STATE OF HAWAII
DEPARTMENT OF TRANSPORTATION
HIGHWAYS DIVISION

GRADING, DRAINAGE & CONSTRUCTION PLAN
FORT WEAVER ROAD
STA. 93+50.00 TO STA. 94+50.00
FORT WEAVER ROAD
SOUTH OF FARRINGTON HIGHWAY
TO THE VICINITY OF RENTON ROAD
SCALE: 1" = 50' DATE: SEPT 1979
SHEET NO. 1 OF 9 SHEETS

FORT WEAVER ROAD
SOUTH OF FARRINGTON HIGHWAY
TO THE VICINITY OF RENTON ROAD

STATE OF HAWAII
DEPARTMENT OF TRANSPORTATION
LAND TRANSPORTATION FACILITIES DIVISION
SUPPLEMENTAL CONSTRUCTION PLAN
MEDIAN CURB AT REL. TONGG RANCH RD.
FORT WEAVER ROAD
SOUTH OF FARRINGTON HIGHWAY
TO THE VICINITY OF RENTON ROAD
SCALE: AS SHOWN DATE: FEB., 1982
SHEET No. 5A OF 9 SHEETS

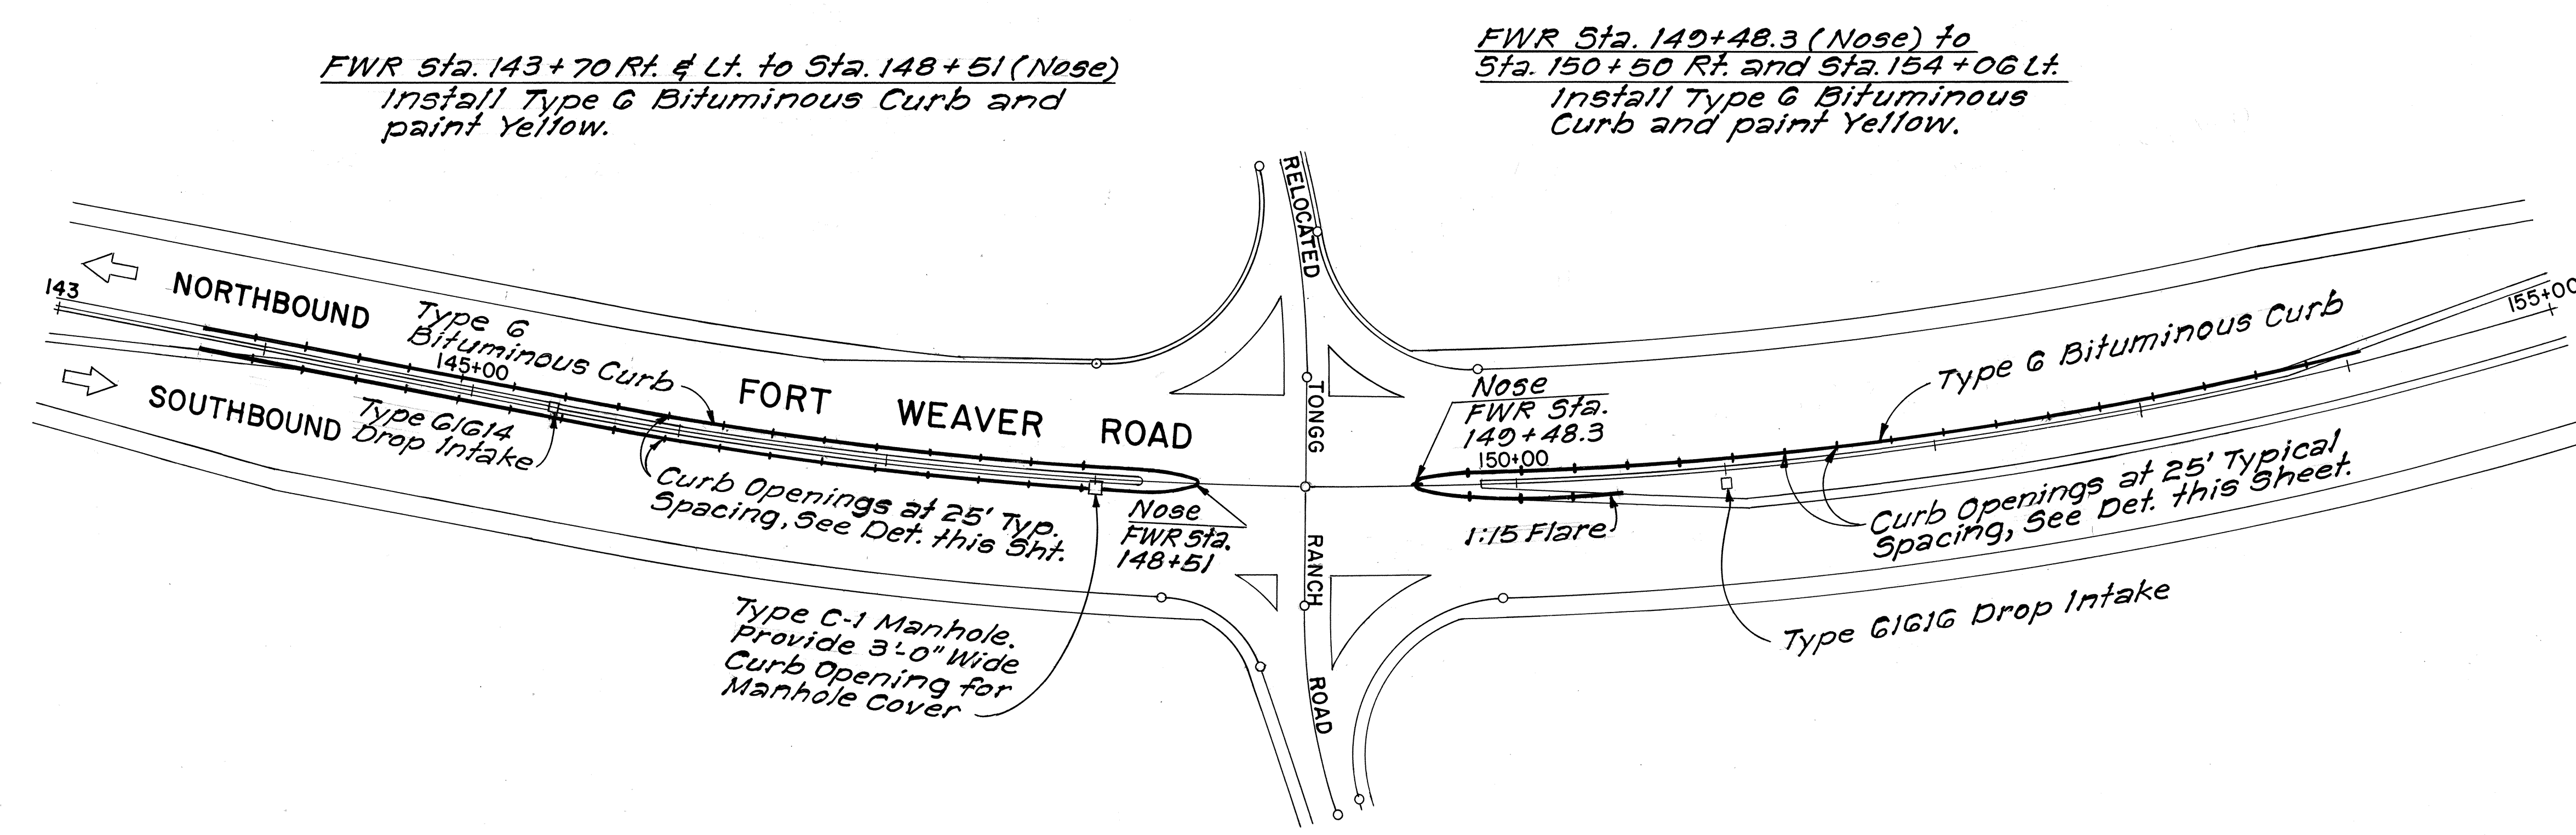
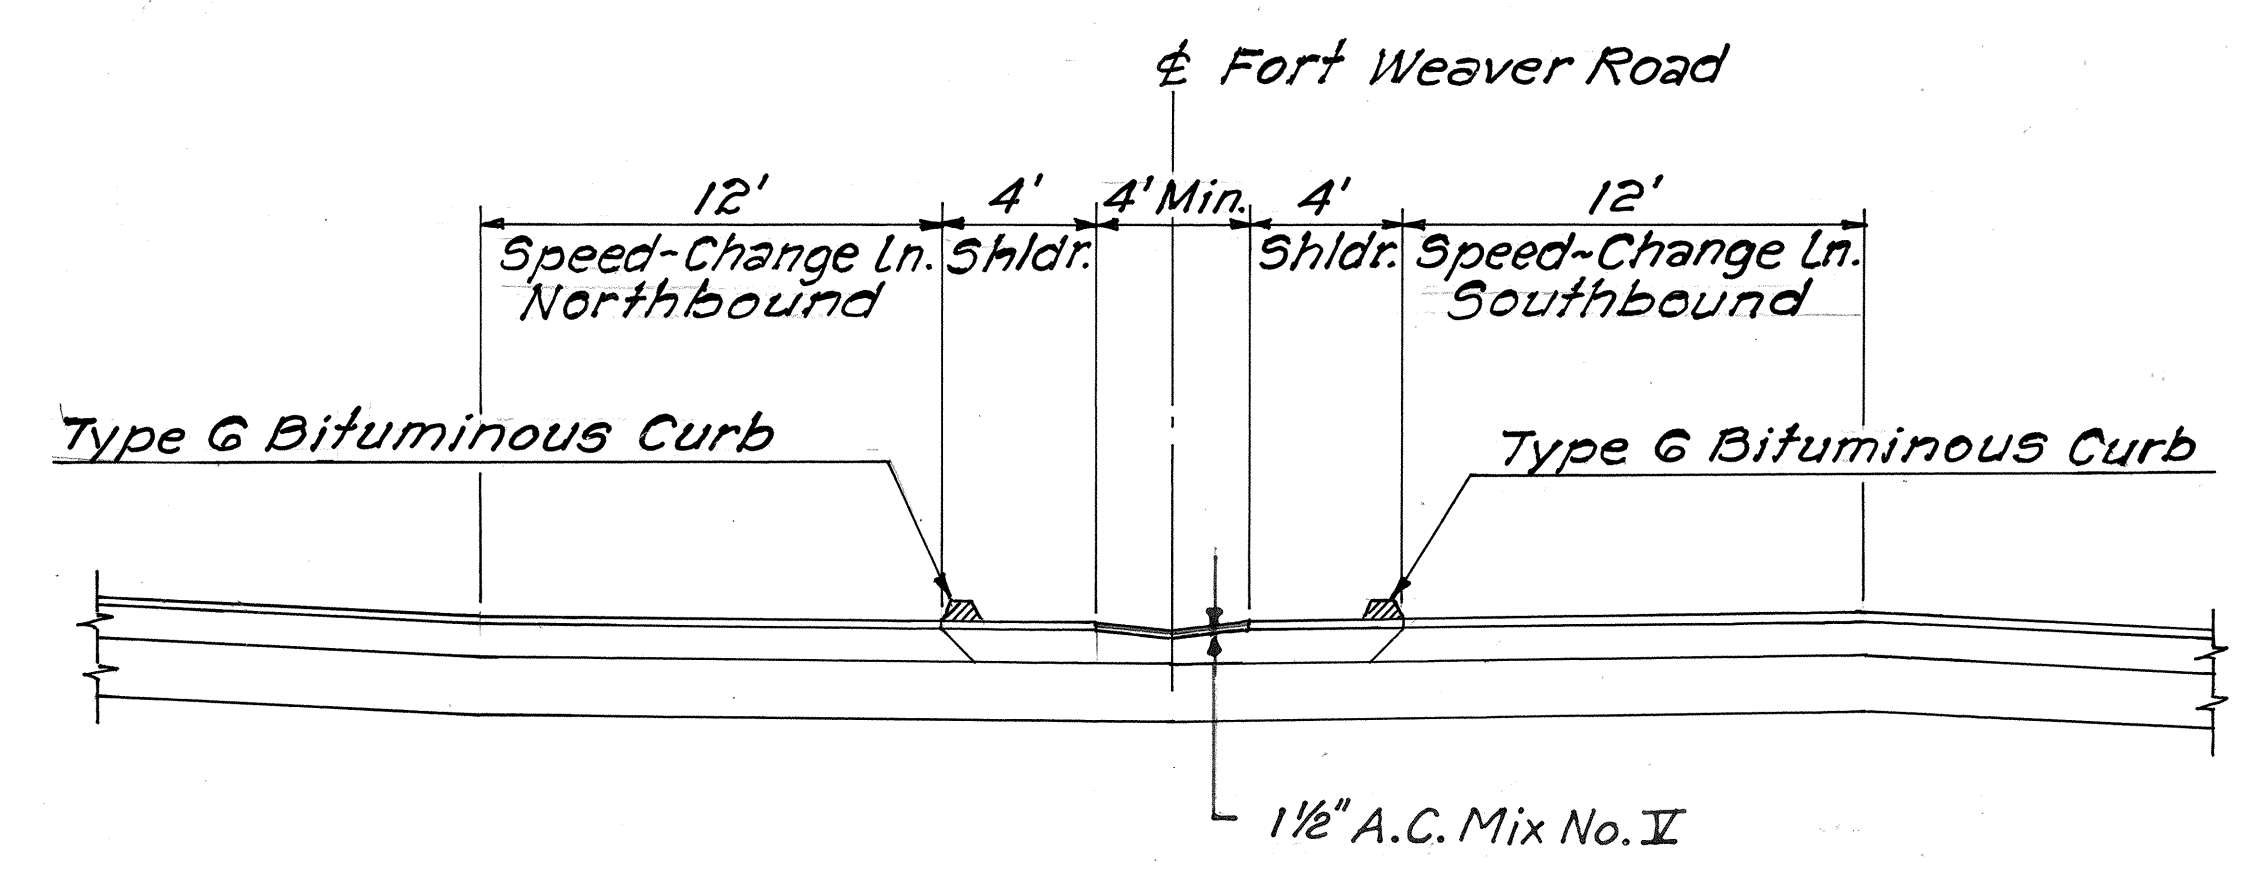
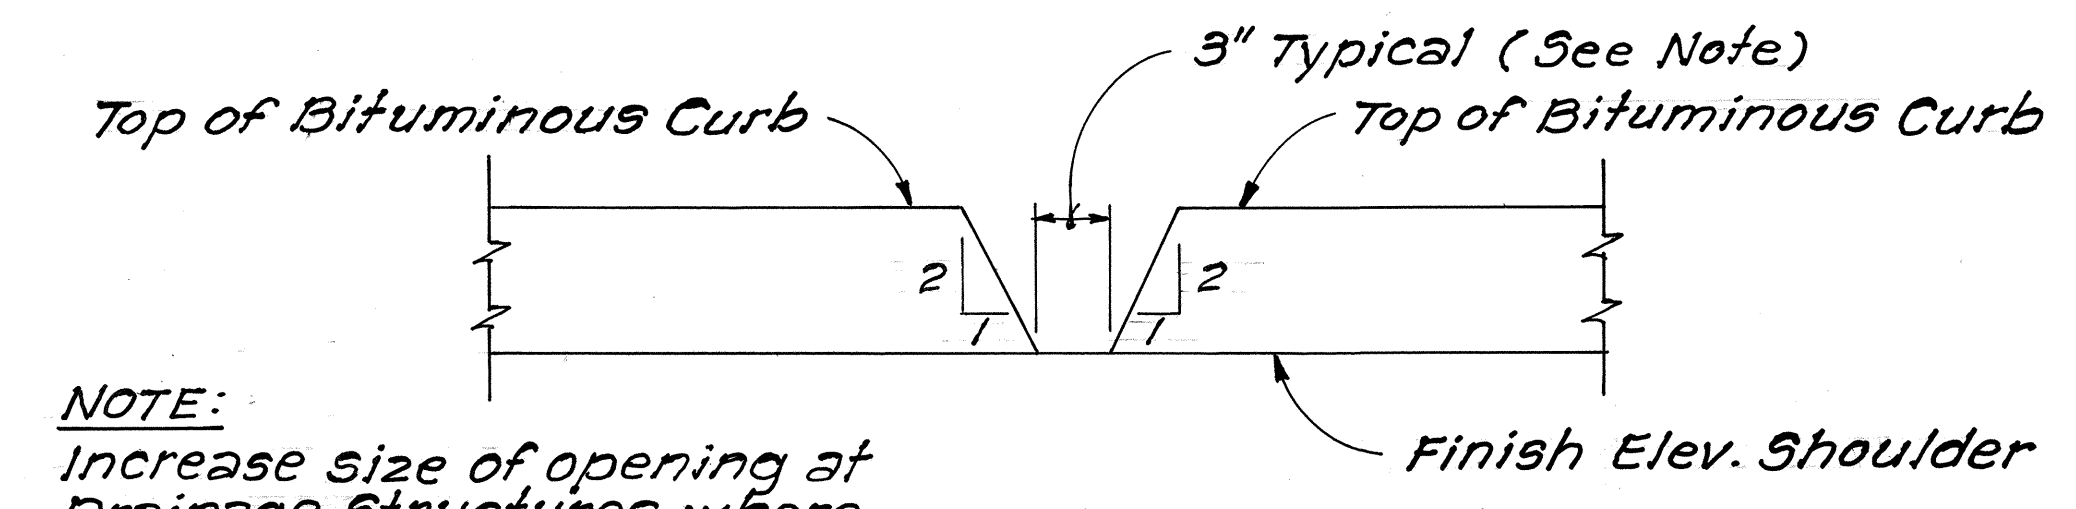
NOTE:
Increase size of opening at Drainage Structures where indicated on Layout Plan.

NOTE:
CONSTRUCTION ITEMS SPECIFIED ON THIS SHEET SUPPLEMENT AND AMEND THE WORK INDICATED ON SHEETS CO ADD. 36 AND CO 88.

GRADING, DRAINAGE & CONSTRUCTION PLAN
RELOCATED TONGG RANCH ROAD
STA. 18+00.00 TO STA. 28+25.00

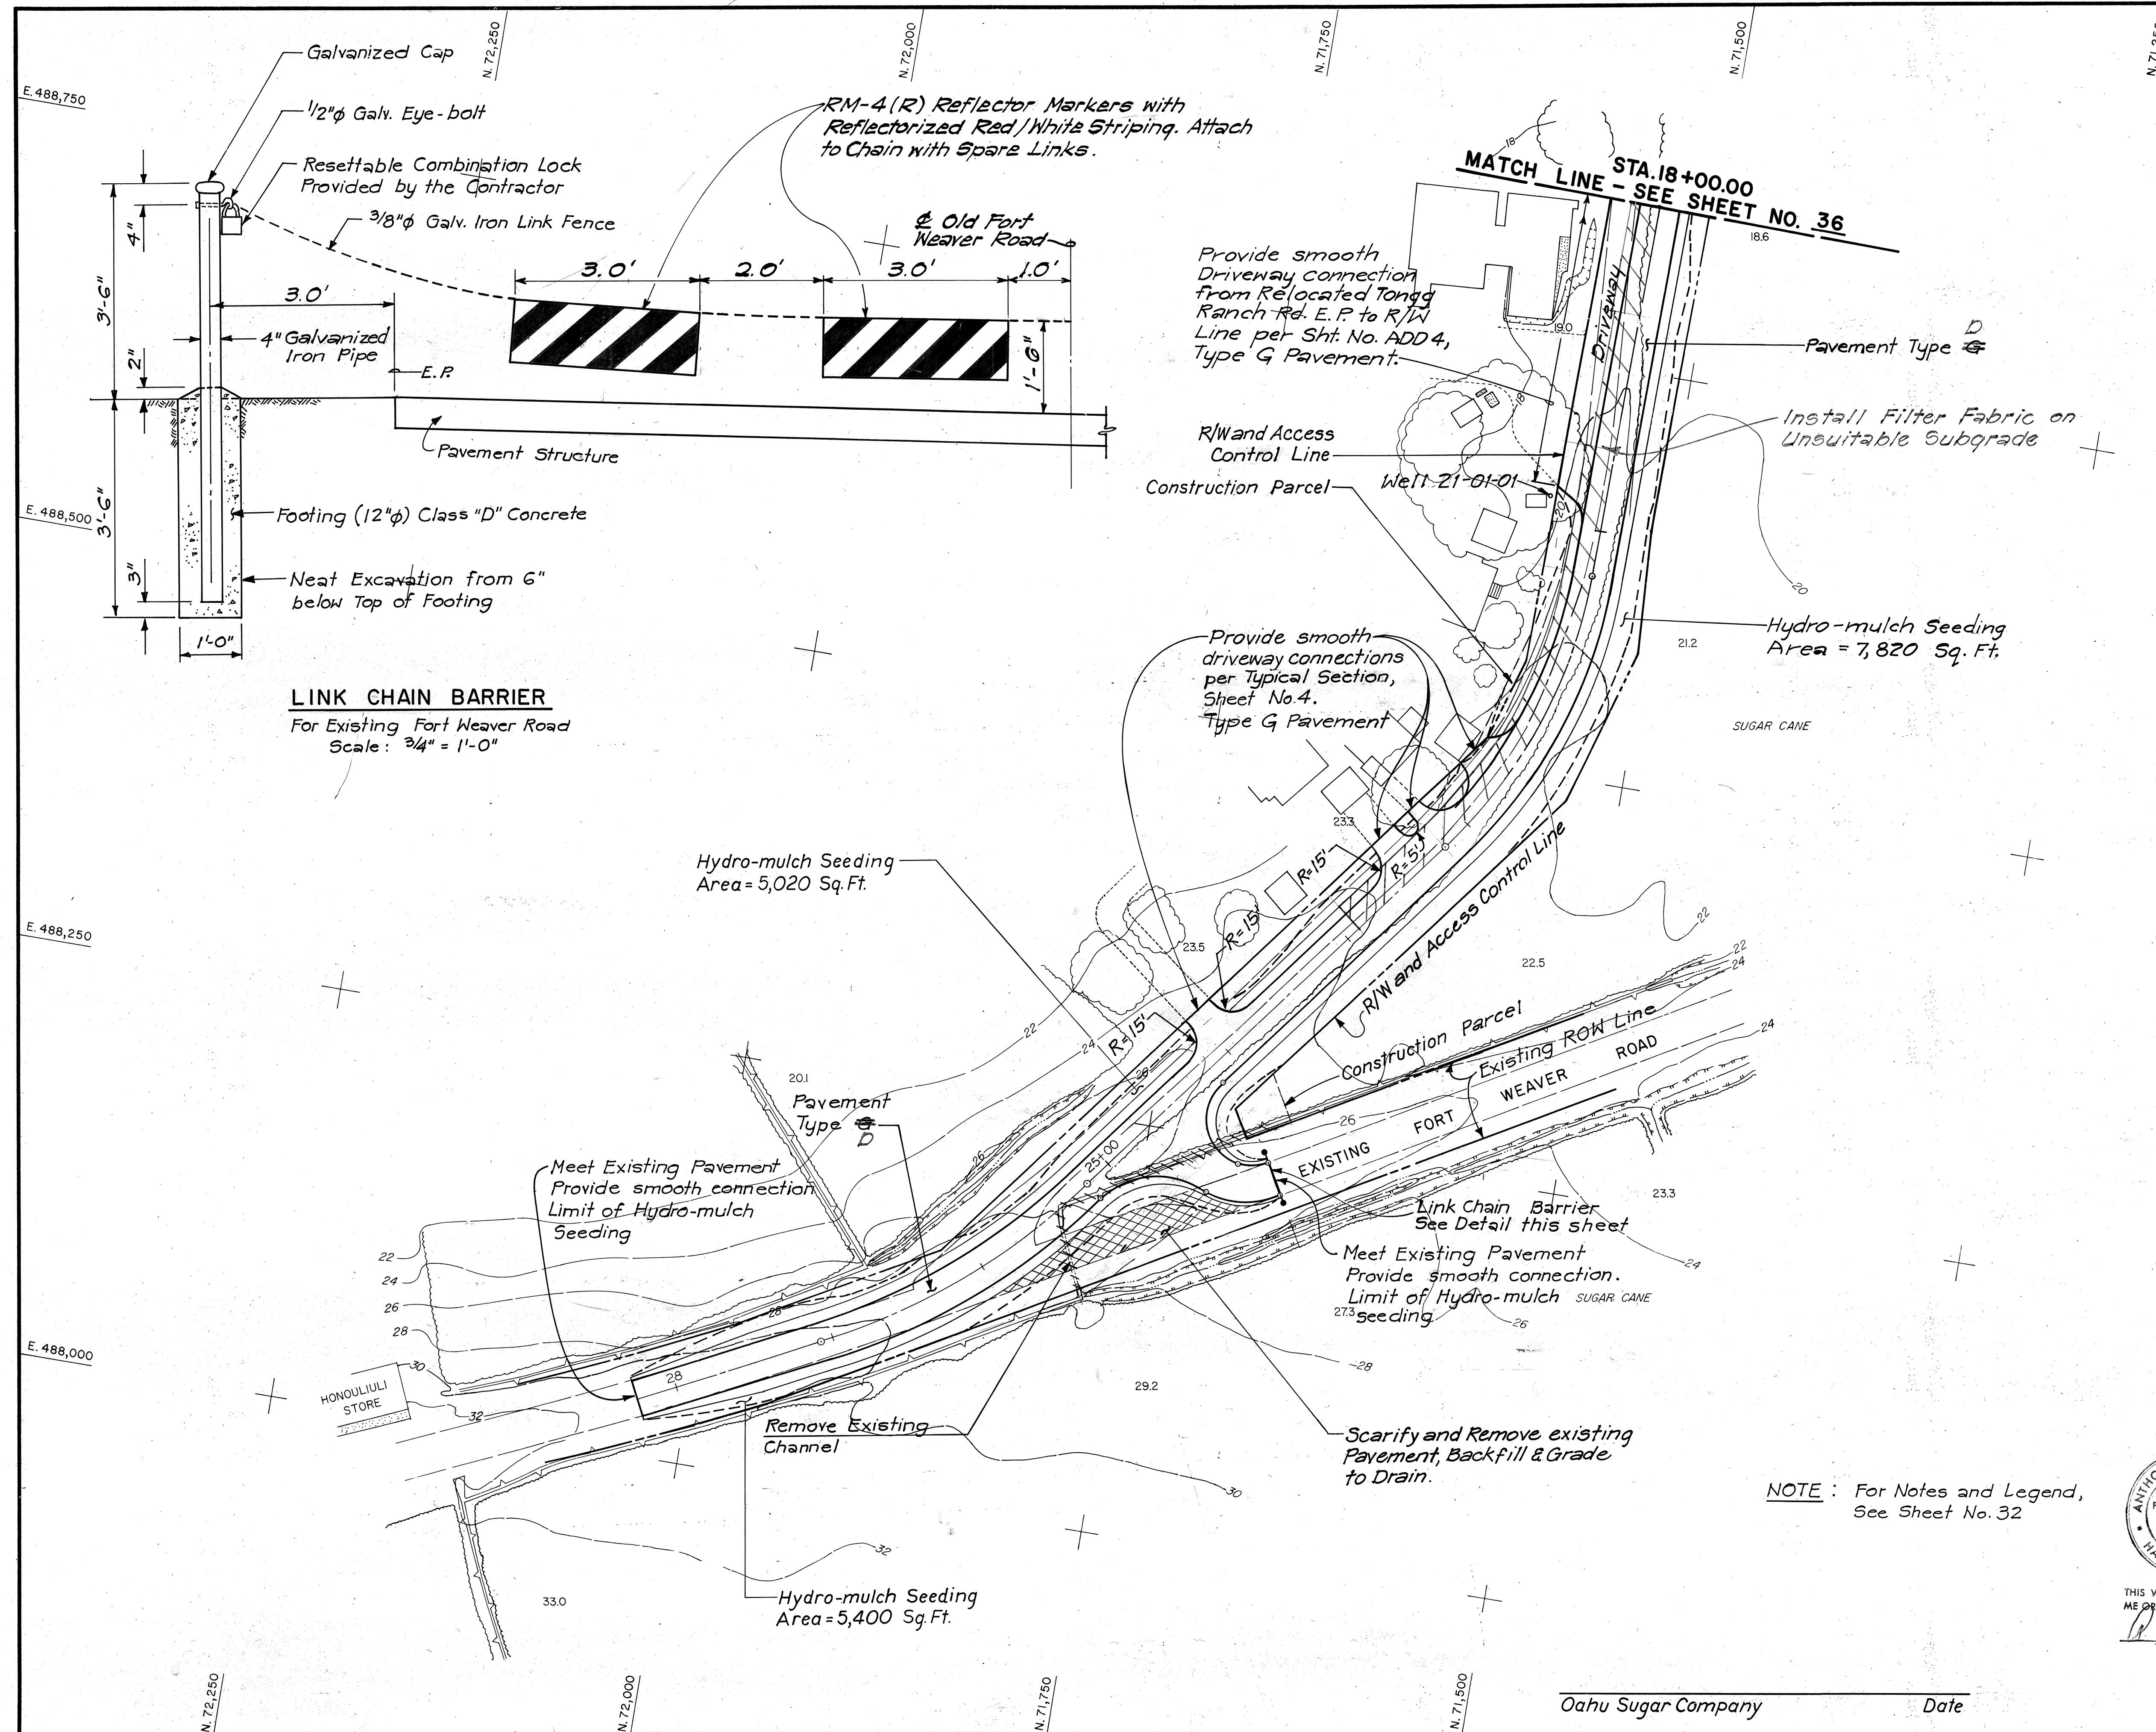
11/6/81 Delete Detour Pavement, Tongg Ranch Rd. Sta. 24+20 to Sta. 25+40. Added Notes previously marked N.I.C. Tongg Ranch Rd. Sta. 24+20 to Sta. 28+25. Delete Siphon No. 11.

11/7/80 Revised R/W Lines along Relocated Tongg Ranch Rd. and Adjusted Limits of Driveway. Corrected Pavement of Relocated Tongg Ranch Rd. between Sta. 18+00 and Sta. 24+20 to Type D, Specified Type G Pavement for Driveways.
